Access Compliance Report

Public Rights-of-Way

(Curb Ramps)

Intersection ID: 46789	Main Street: STOWE_ACRES_DR	Cross Street: WILTON_GATE_DR	Location: SE
ADA ID: B3D621ECB5A2	Ramp Type: PerpDiag	Initial Pass/Fail: Fail	Overall Compliance: No
Severity Score: 22.5			
Codes/Mitigation Info/Possible Solution		Field Measurements/Component Compliance

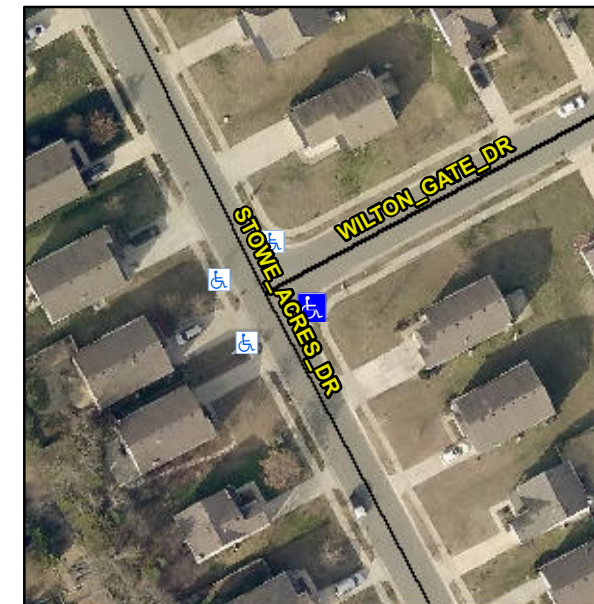
Not Found, R304.5.1, R304.2.2, R304.5.3

Compliance	Description	Data	Compliance	Description	Data
N/A	Ramp Length (in)	48.5	No	Ramp Slope (%)	9.3
No	Ramp Width (in)	37.5	No	Ramp XSlope (%)	2.8
N/A	Flare Type LT	N/A	N/A	Flare Type RT	N/A
N/A	Flare Slope LT (%)	N/A	N/A	Flare Slope RT (%)	N/A
N/A	Flare Traversable LT?	N/A	N/A	Flare Traversable RT?	N/A
N/A	Landing Length (in)	N/A	N/A	DWS Provided?	N/A
N/A	Landing Width (in)	N/A	N/A	DWS Contrast?	N/A
N/A	Landing Slope (%)	N/A	N/A	DWS Length (in)	N/A
N/A	Landing X Slope (%)	N/A	N/A	DWS Full Width?	N/A
N/A	Landing Curb? (Y/N)	N/A	N/A	DWS Offset (in)	N/A
N/A	Shared Landing?	N/A			
N/A	Gutter Ponding?	N/A	N/A	Gutter Slope (%)	N/A
N/A	Gutter Lip Ht (in)	N/A	N/A	Gutter X Slope (%)	N/A
N/A	Painted X Walk1?	No	N/A	Painted X Walk2?	No
	X Walk 1 Direction	To N		X Walk 2 Direction	To W
N/A	X Walk 1 Width (in)	N/A	N/A	X Walk 2 Width (in)	N/A
	X Walk 1 Slope (%)	1.1		X Walk 2 Slope (%)	0.0
	X Walk 1 X Slope (%)	0.6		X Walk 2 X Slope (%)	0.0

Remove & Replace Curb Ramp With Two New Directional Ramps or Equivalent.
